# ASSESSMENT OF DAM SAFETY OF COAL COMBUSTION SURFACE IMPOUNDMENTS

**Gulf Power  
Plant Scholz  
Sneads, Florida**

Prepared for  
*U.S. Environmental  
Protection Agency  
Washington, D.C.*

October 2012

Photo 102: Upper Middle Pond – Divider embankment interior slope, close up of erosion rill, looking west.

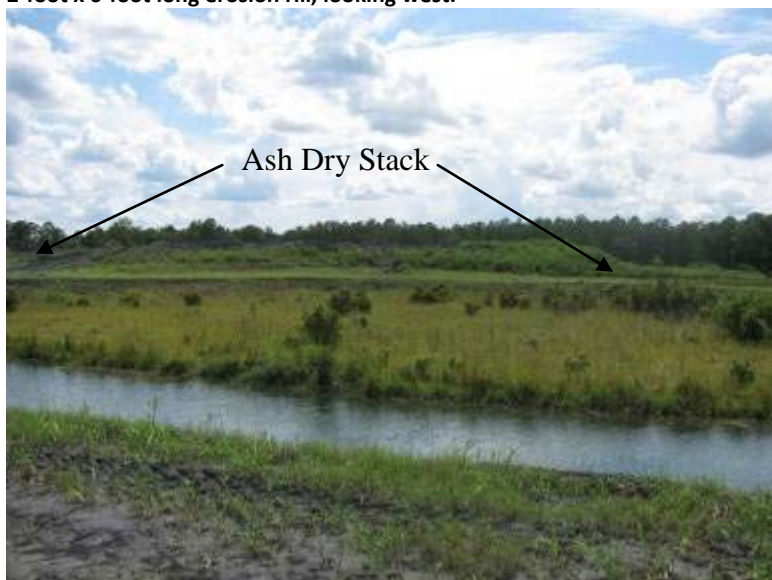
Photo 101: Upper Middle Pond – Divider embankment interior slope, 2-foot x 2-foot x 6-foot long erosion rill, looking west.
